Division 2000: Pavement Systems

DIVISION 2000 PAVEMENT SYSTEMS**TABLE OF CONTENTS**

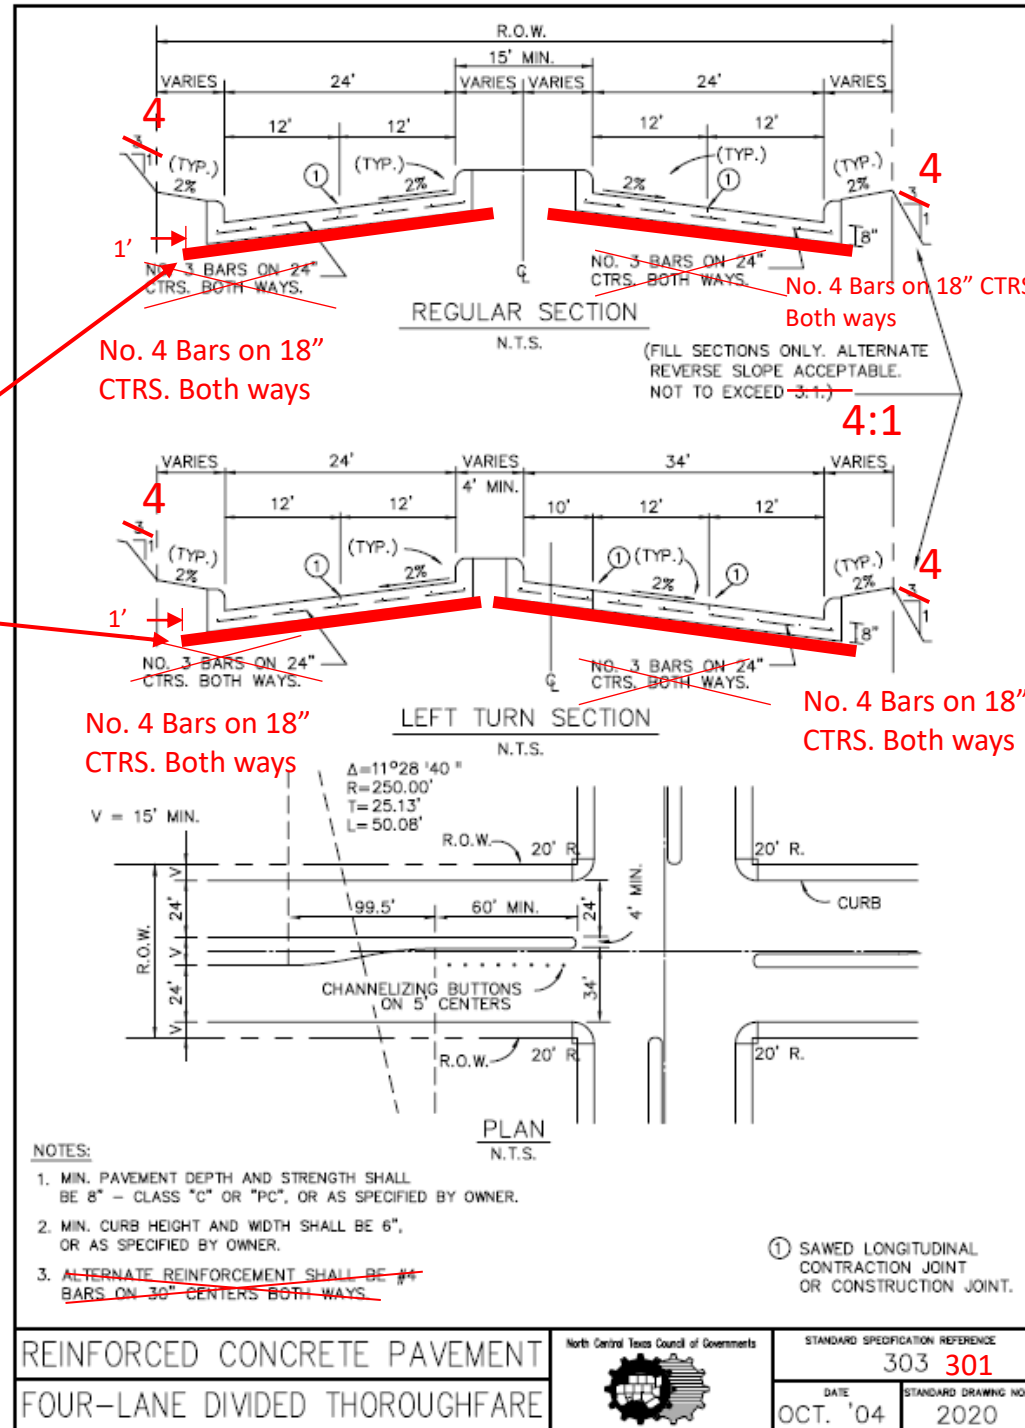
Make sure the format, text size, arrow size, etc. is consistent on the page.

Show subgrade box on all Division 2000 drawings.

Replace Plan with a more general layout to include crosswalks, ADA ramps, striping, and possibly additional lane width for bicycle lanes per TxDOT

2030

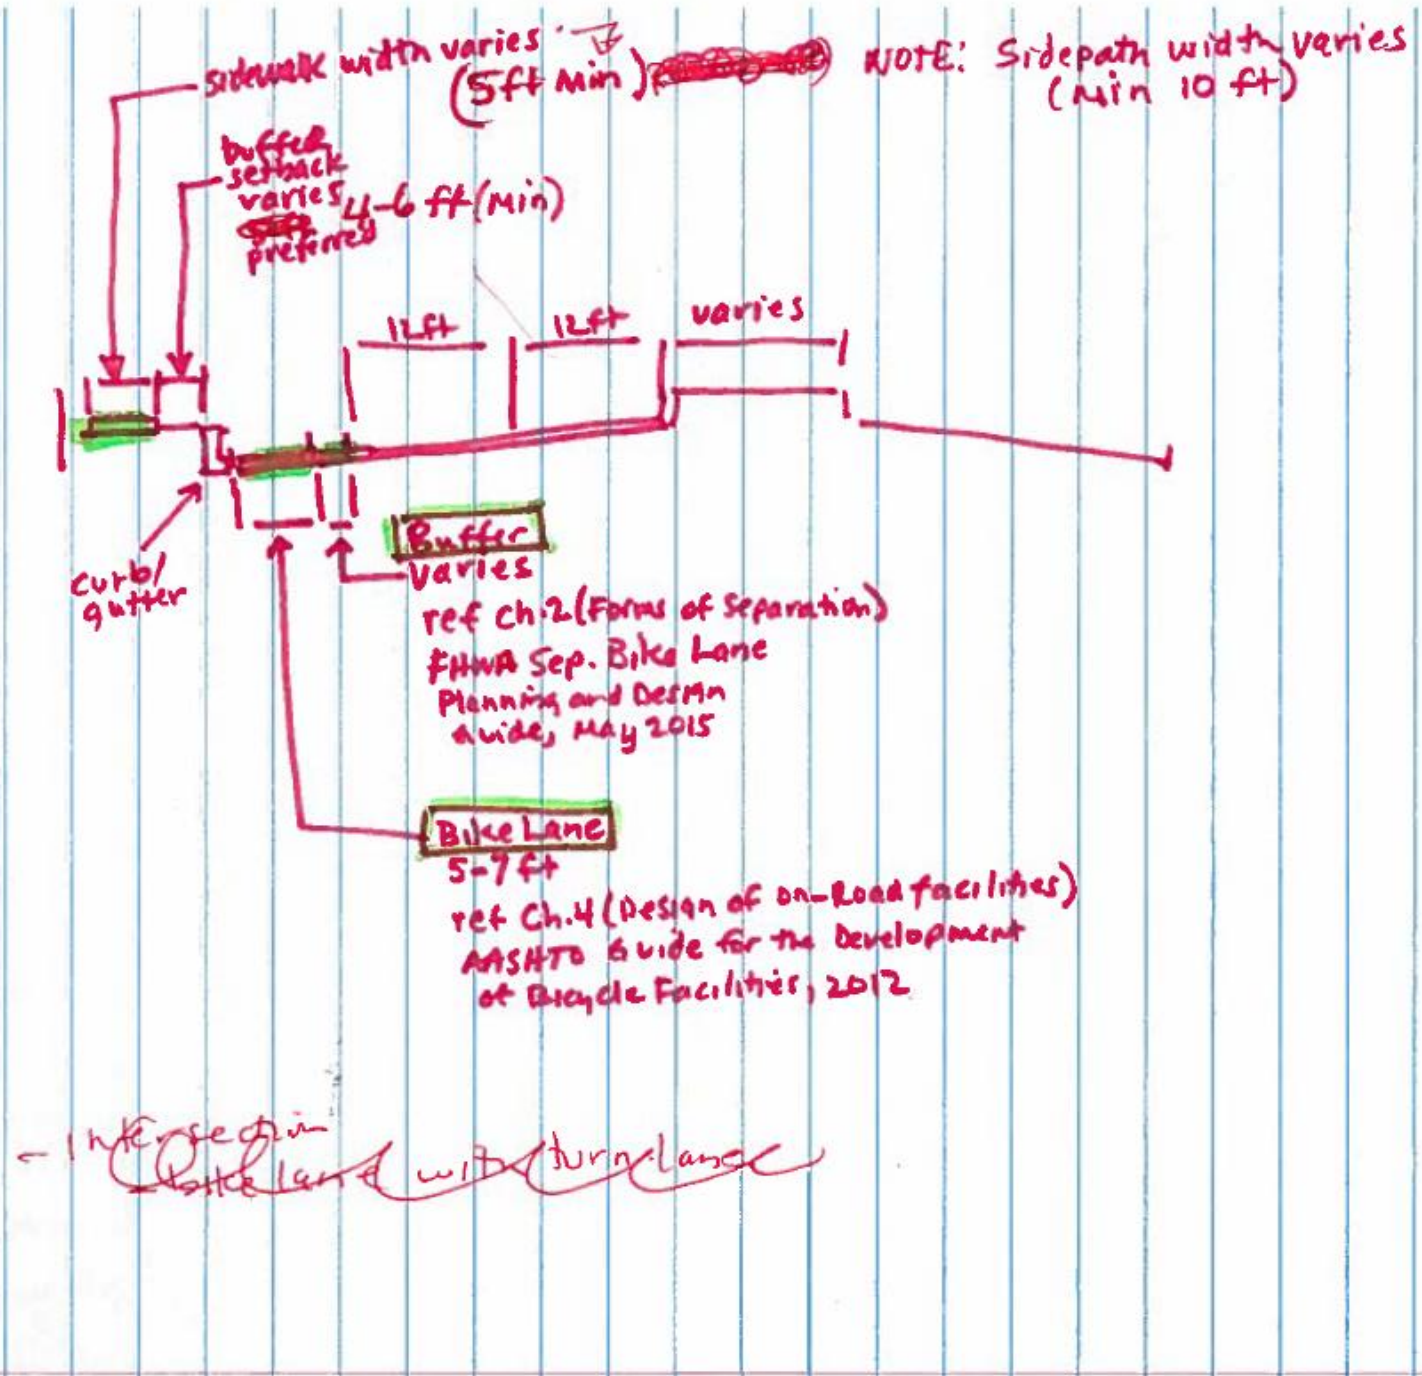
Make sure the format, text size, arrow size, etc. is consistent on the page.

Show subgrade box on all Division 2000 drawings.

Replace Plan with a more general layout to include crosswalks, ADA ramps, striping, and possibly additional lane width for bicycle lanes per TxDOT

- ALL REINFORCEMENT SHALL BE ~~3~~⁴ BARS ON ~~30~~¹⁸ CENTERS BOTH WAYS, EXCEPT WHERE NOTED.
- ALTERNATE REINFORCEMENT SHALL BE ~~#4~~ BARS ON 30" CENTERS BOTH WAYS.
- PAVEMENT STRENGTH SHALL CONFORM TO CLASS "C" OR "PC" CONCRETE, OR AS SPECIFIED BY THE OWNER.

LEFT TURN SECTION

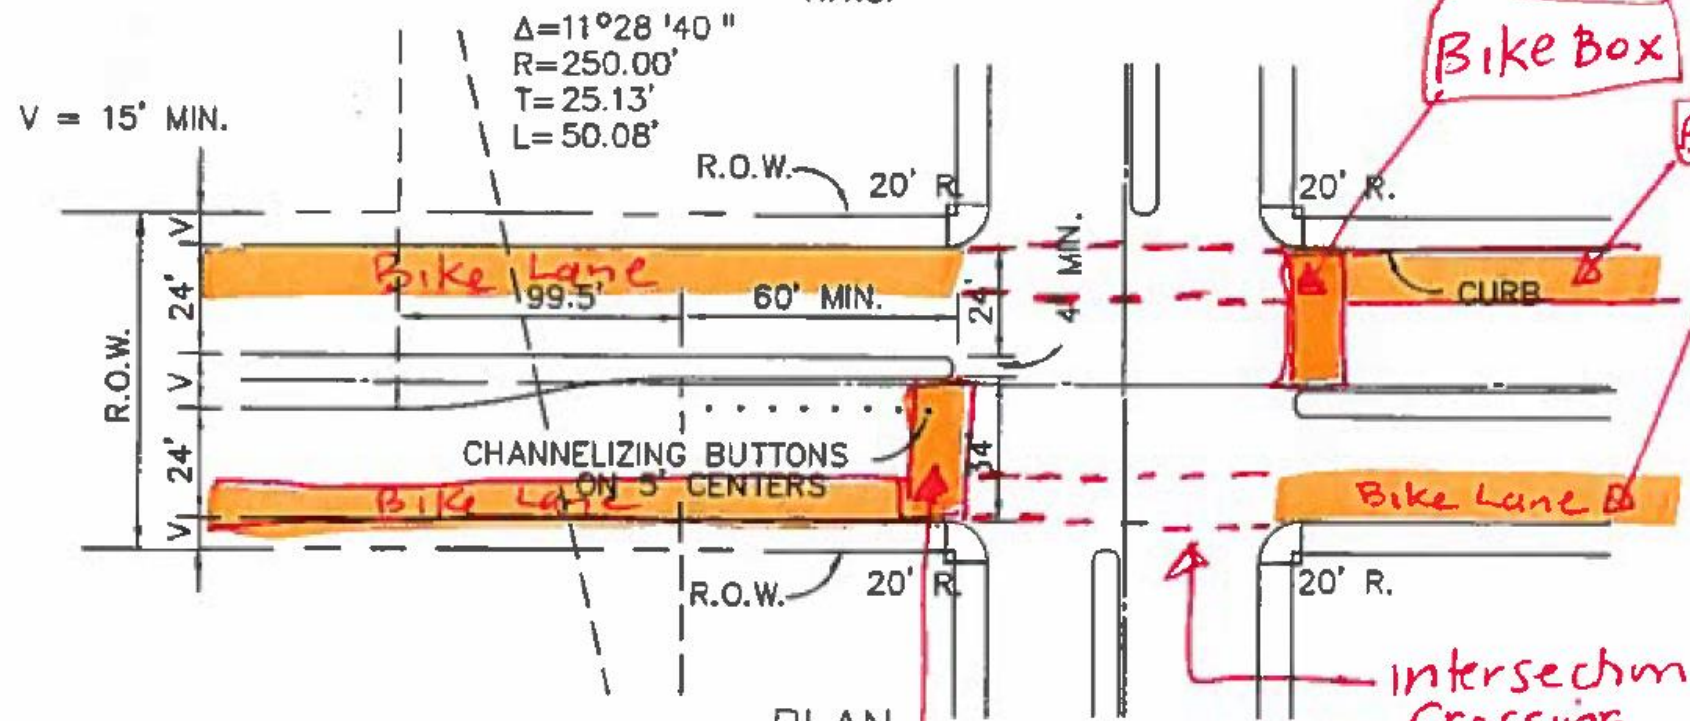
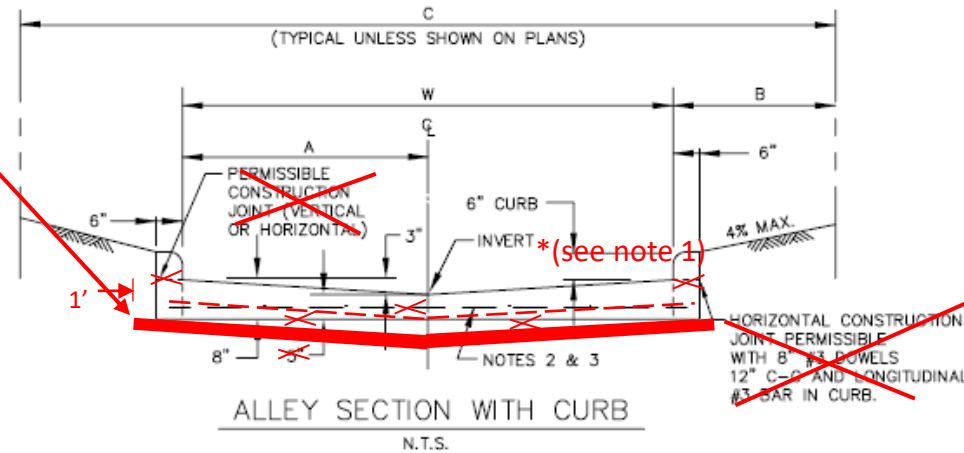
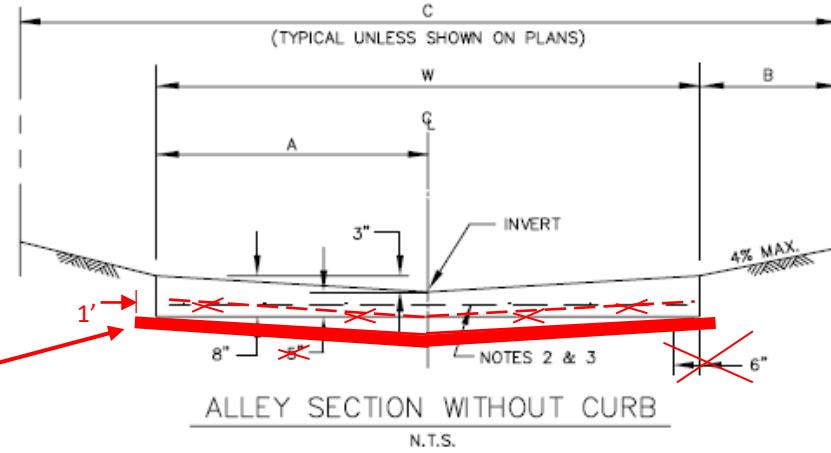
Show a shared use path on the right side of the section details. Add note describing that two different options for multimodal transportation are being shown but installation should be specified by owner.

Shared path width is a minimum of 10'.

Everywhere with ASHTO note should say refer to note 5 and make it one note at the end.

Add "Separate curb/gutter as necessary (reference drawings 2120)" to callouts for curb/gutter

If there's a required bike lane the buffer should be 1'-3' depending on the speed.

Sidewalks should be 5' as directed by city but can be reduced to a minimum of 3' sidewalk with 5' bulb out.

Put the plan views on a separate page (2015 and 2025).

Show a plan view with bike lanes and without.

Remove bike box on plan view and get rid of ASHTO reference.

Add curb ramp, cross walk markings, and make sure the median nose is not in the cross walk on the plan view.

The radius for the curb on the plan view should be 30'.

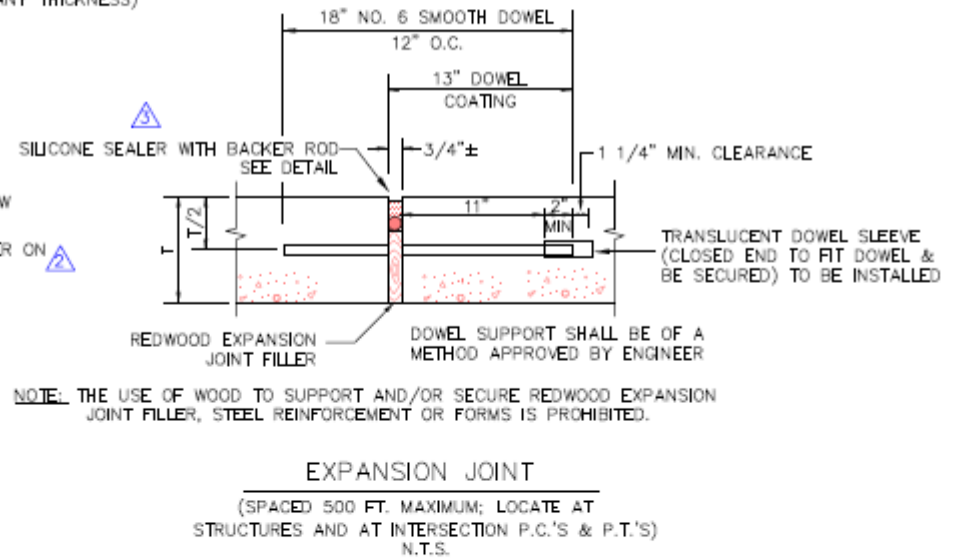
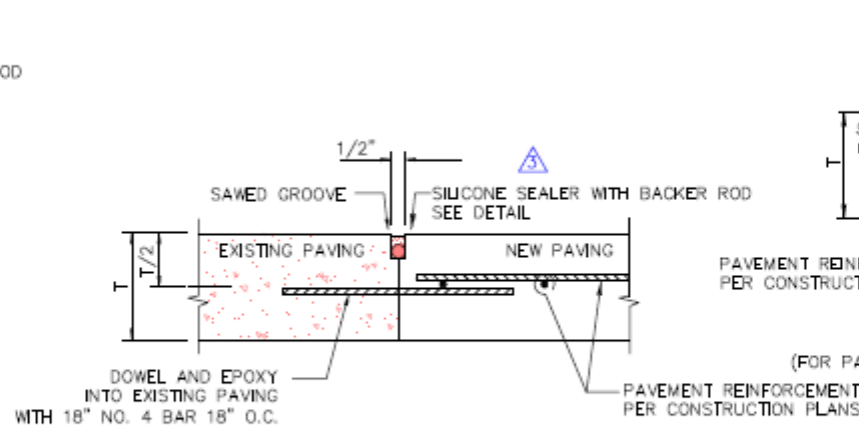
Show backer rod in detail, compare to Coppel detail 2050.

STREET HEADER FOR FUTURE PAVEMENT
N.T.S.

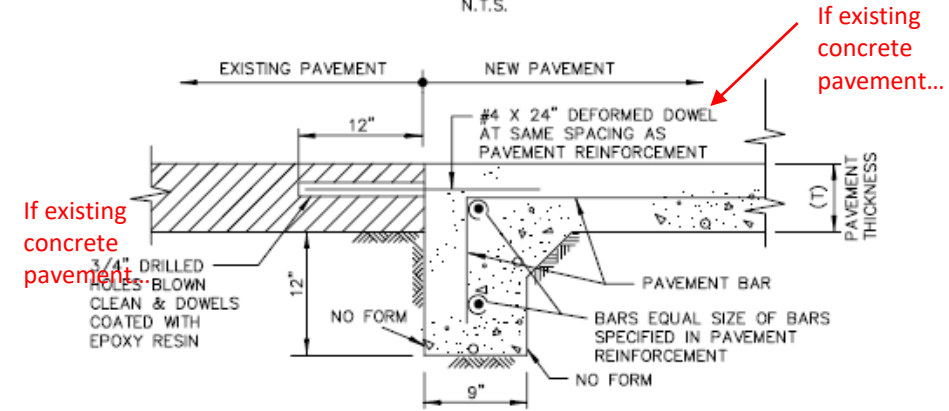
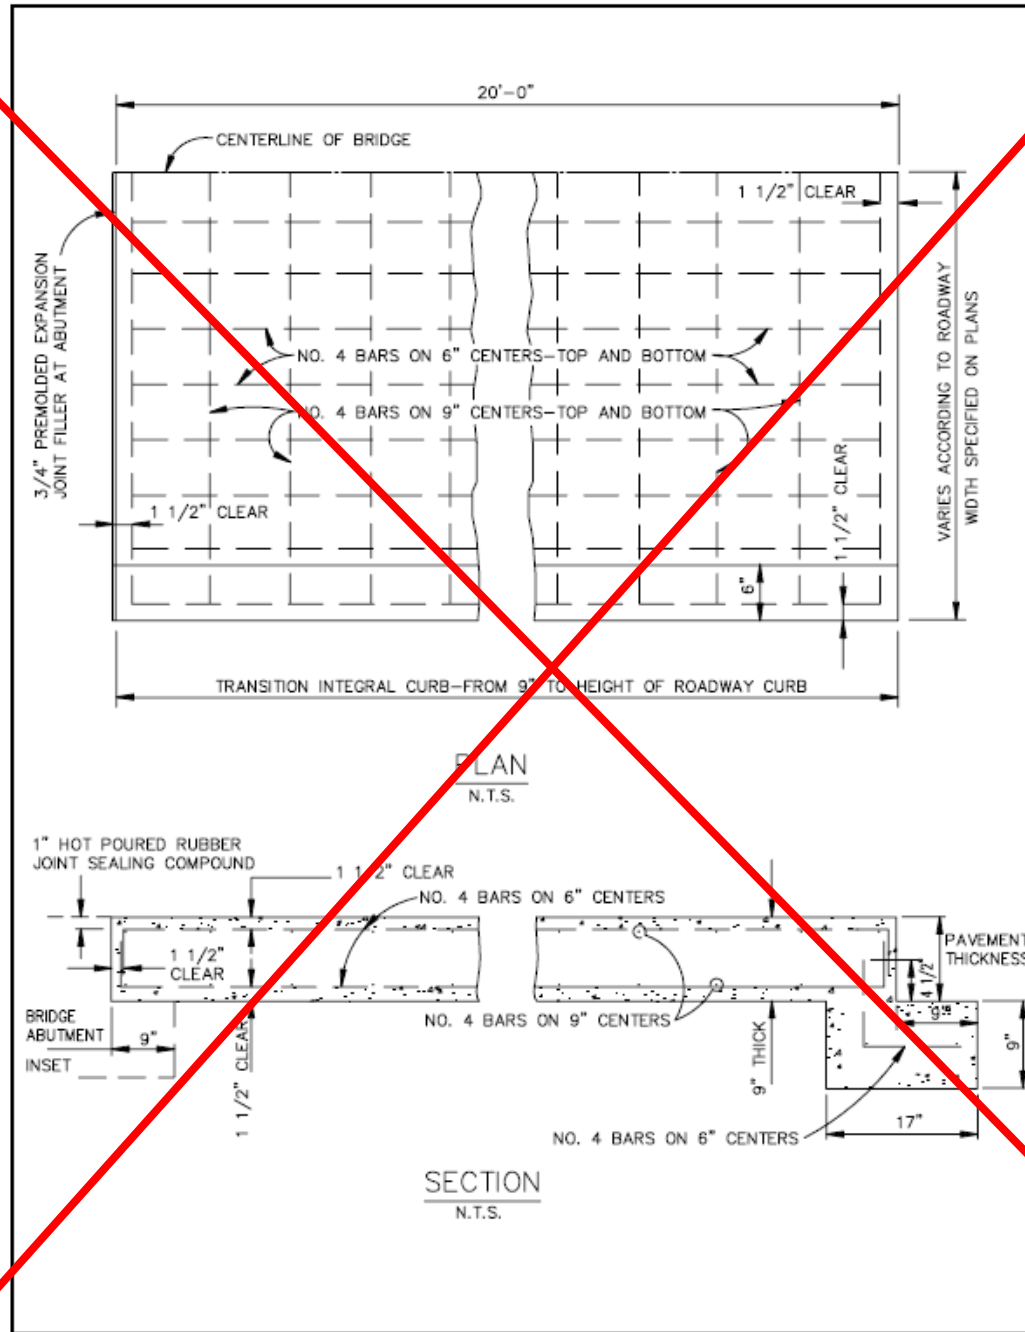
Scale down the top 2 drawings to the same scale as the bottom one

Remove detail and reference TxDOT detail in specs if needed

CURB RAMPS	North Central Texas Council of Governments	STANDARD SPECIFICATION REFERENCE	
		DATE OCT. '04	STANDARD DRAWING NO. 2125A

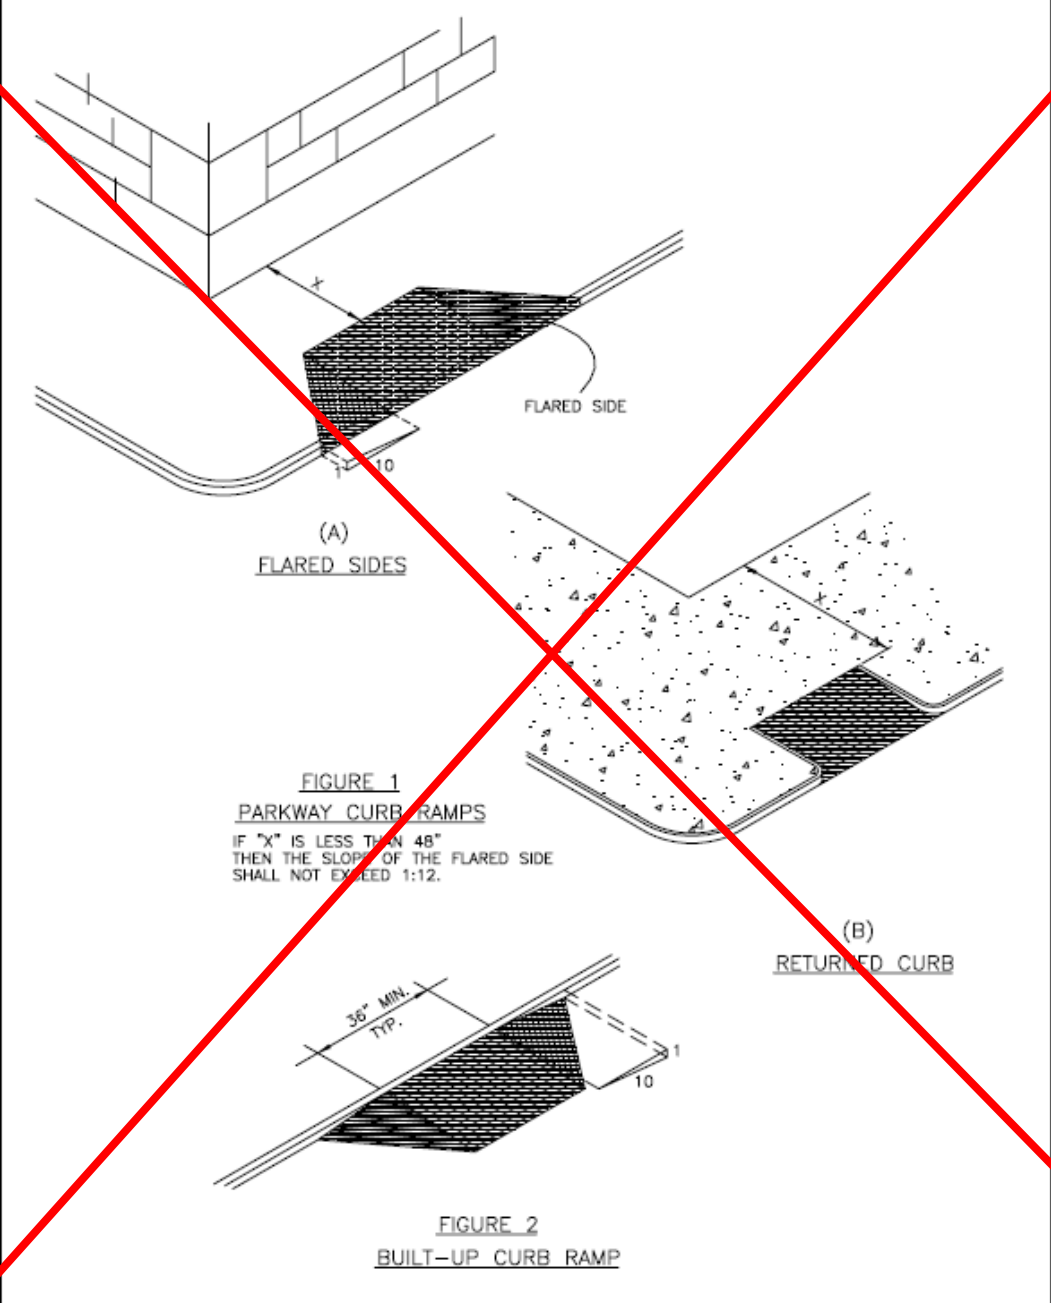
Make a note and graphical change on integral curb and gutter detail to show rebar.

Make rebar the same size in all details and callout as #4 bars.

Update and remove 2125A or update to reference other detail
